CITY OF ALBUQUERQUE

August 24, 2021

Re: JB Henderson Fabrication Facility
10200 Bell Ave SE
Traffic Circulation Layout
Architect's Stamp 01-15-2021 (L20-D075)

SHEET NAME & NO.
ARCHITECTURAL
SITE PLAN
AS-101

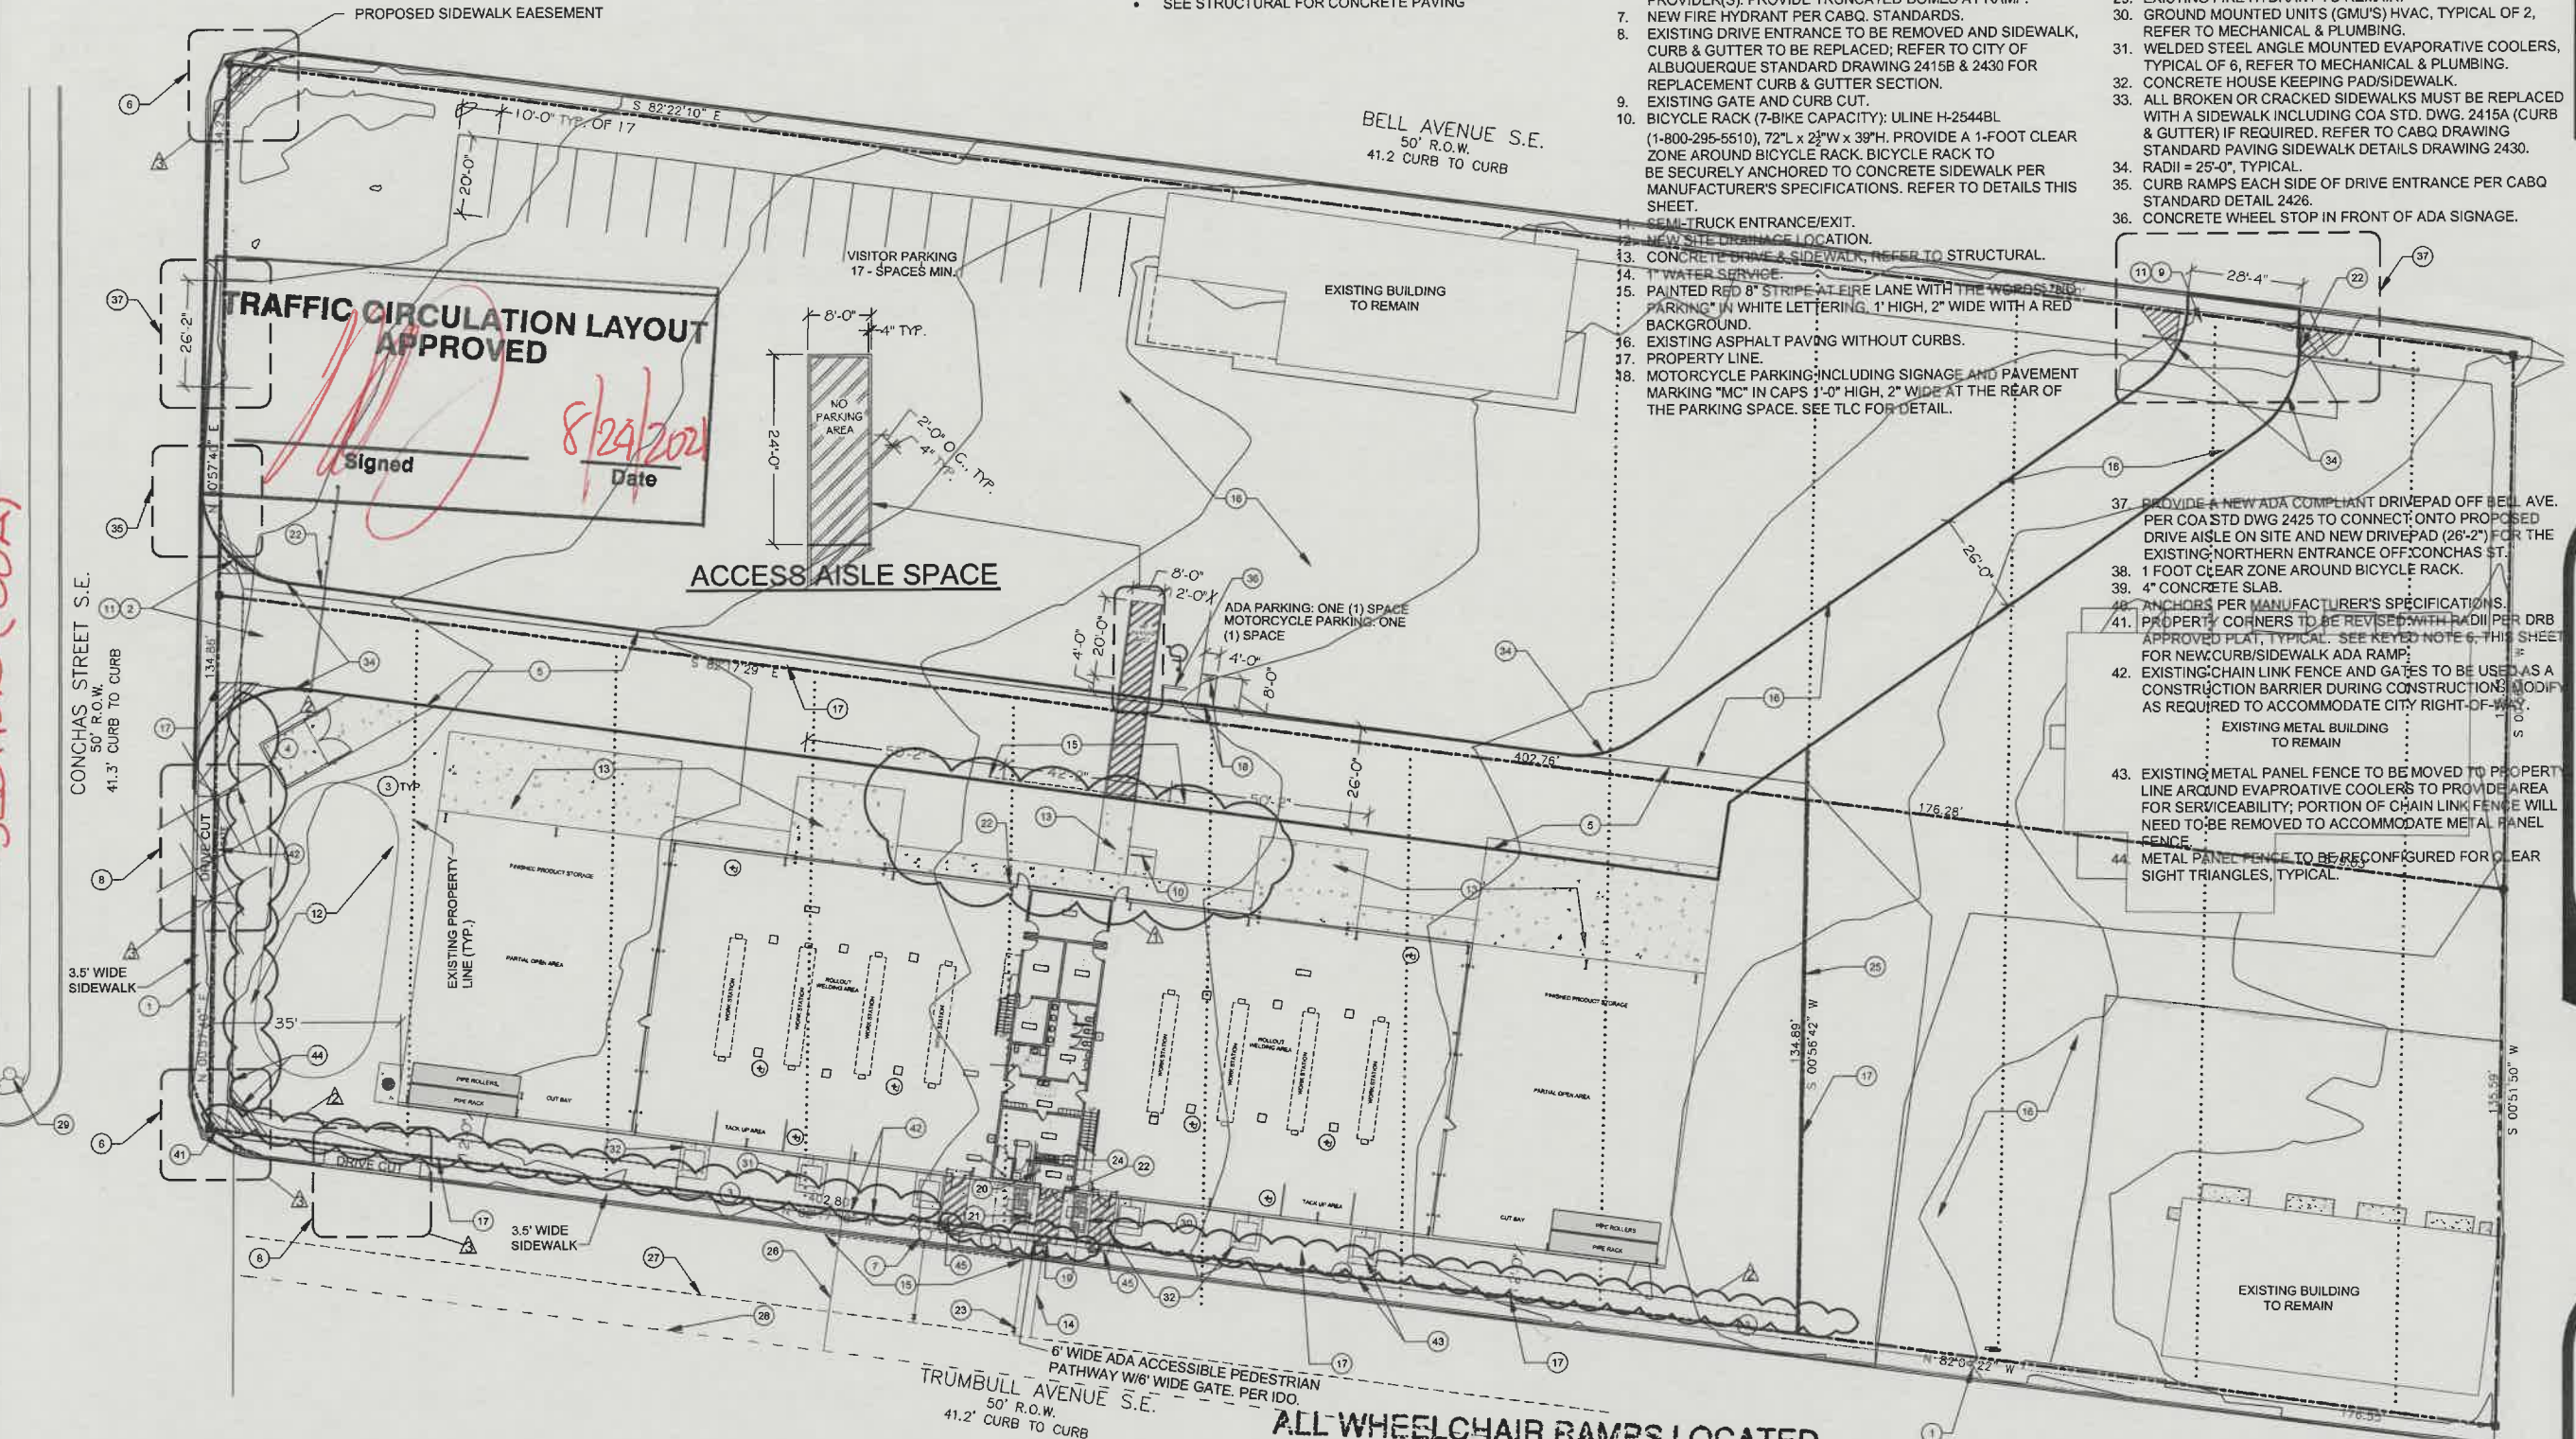
CONDITION OF FINAL C.O. APPROVAL:
SIDEWALK EASEMENT BE APPROVED
AND COPY PROVIDED TO TRANSPORTATION
SECTION (COA)

ALL WHEELCHAIR RAMPS LOCATED
WITHIN THE PUBLIC RIGHT OF WAY
MUST HAVE TRUNCATED DOMES.
